AMENDMENTS TO DRAWING FIGURES

The attached sheet of drawings includes a new drawing, Fig. 13a. That sheet, which now includes Figs. 13 and 13a, replaces the original sheet which included Fig. 13.

Fig. 13a

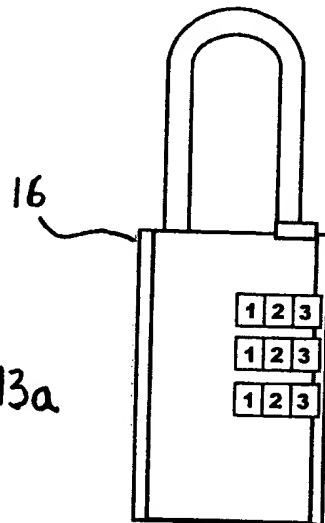
Fig 13a was added in response to Examiner's objection under 37 C.F.R. § 1.83(a), and shows the claimed means for locking the hasp bar having a code-operated combination locking mechanism.
